SERVICE INSTRUCTION

Introduction of sodium filled exhaust valves for ROTAX® Engine Type 914 (Series)

ATA System: 72-00-00 Valve train

Fig. 1
Exhaust valves (Old and New)

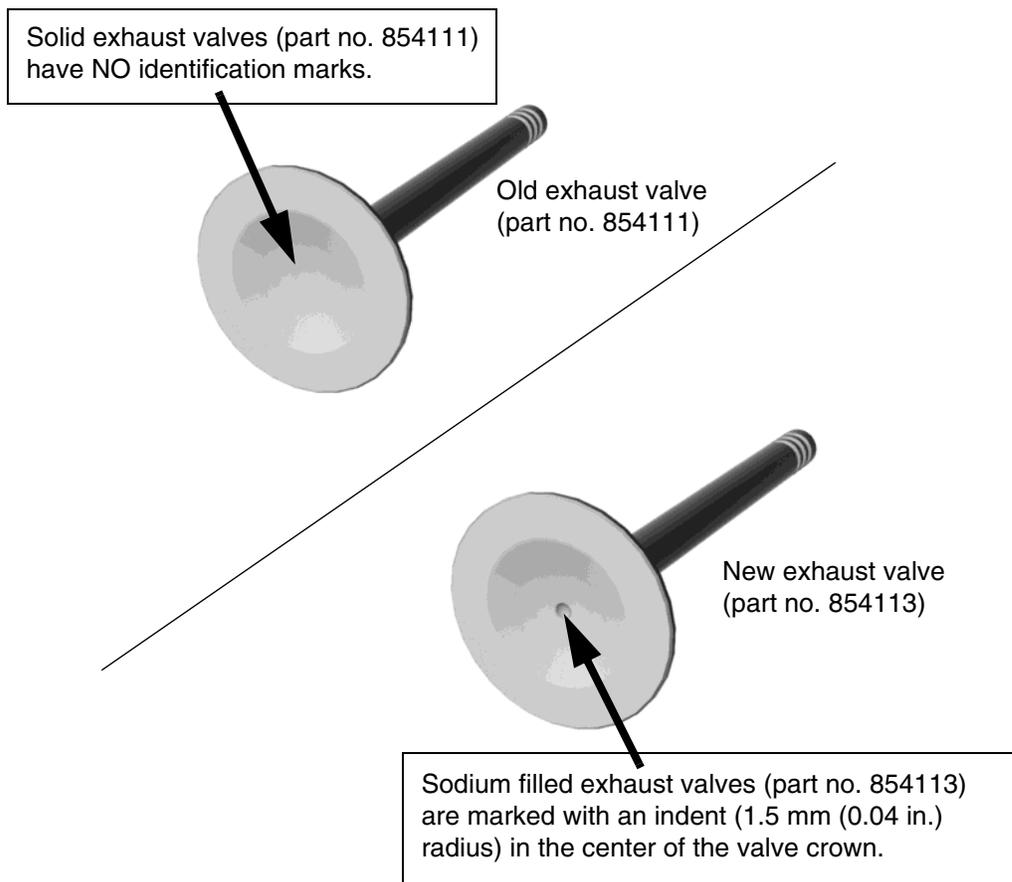
Due of ROTAX' commitment to innovation and continuous product improvement a new type of exhaust valve for the engine type 914 Series will be introduced. The new sodium filled valve (part number is listed in section 2.3) will provide further improved wear characteristics especially in corrosive environments (e.g. 100% AVGAS operation).

Fig.no.	New p/n	Qty/engine	Description	Old p/n	Application
1	854113	as required	Exhaust valve 32 mm	854111	Valve train

Maintenance procedures and wear limits for sodium filled exhaust valves (part no. 854113) are identical with the solid exhaust valves (part no. 854111).

NOTE: It is NOT mandatory to retrofit engines to the new sodium exhaust valves (part no. 854113). Exhaust valves can be individually replaced with sodium valves, allowing the mixing of the different exhaust valves within an engine. When installing sodium exhaust valves, the engine log book or overhaul record must reflect the execution, including cylinder head position etc.
